PREVOST

WARRANTY BULLETIN

WB13-62B

DATE :	SEPTEMBER 2013	SECTION :	10 - Front axle
EXPIRATION:	SEPTEMBER 2015		
SUBJECT :	TORQUE INSPECTION ON FRONT AXLE SUPPORT BOLT

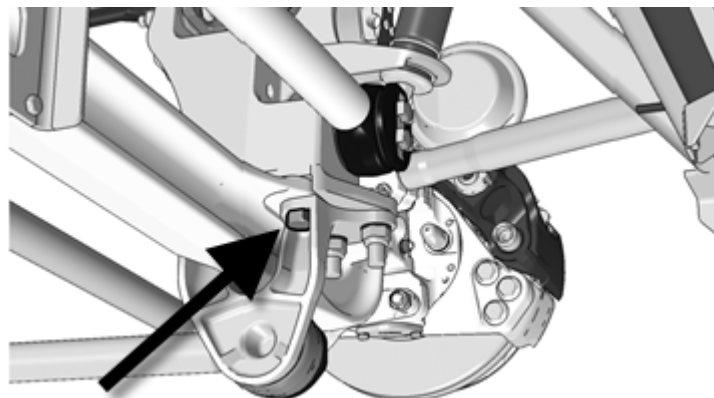
1. On the front axle, left side (driver's side). Locate this bolt (arrow).

2. Verify the torque on this bolt.

Value should be

255 +/- 25 lbf-ft. (**230 - 280** lbf-ft).

If value is within range, clean and apply torque seal mark.

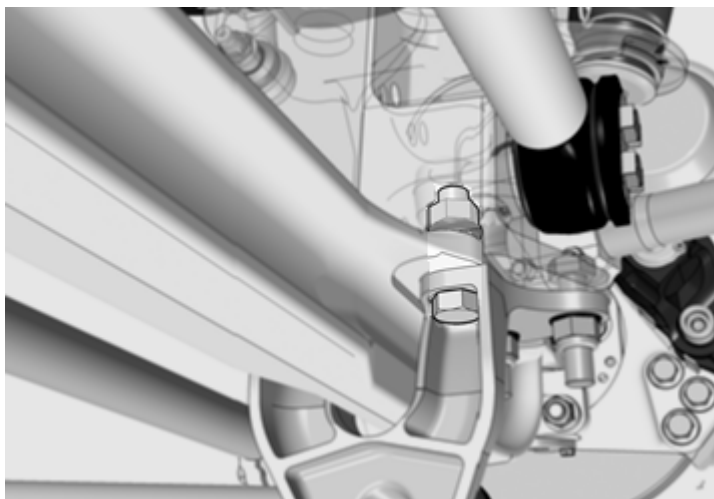
3. If torque is outside the required range, unscrew half a turn and tighten to 255 lbf-ft.

Clean and apply torque seal mark.
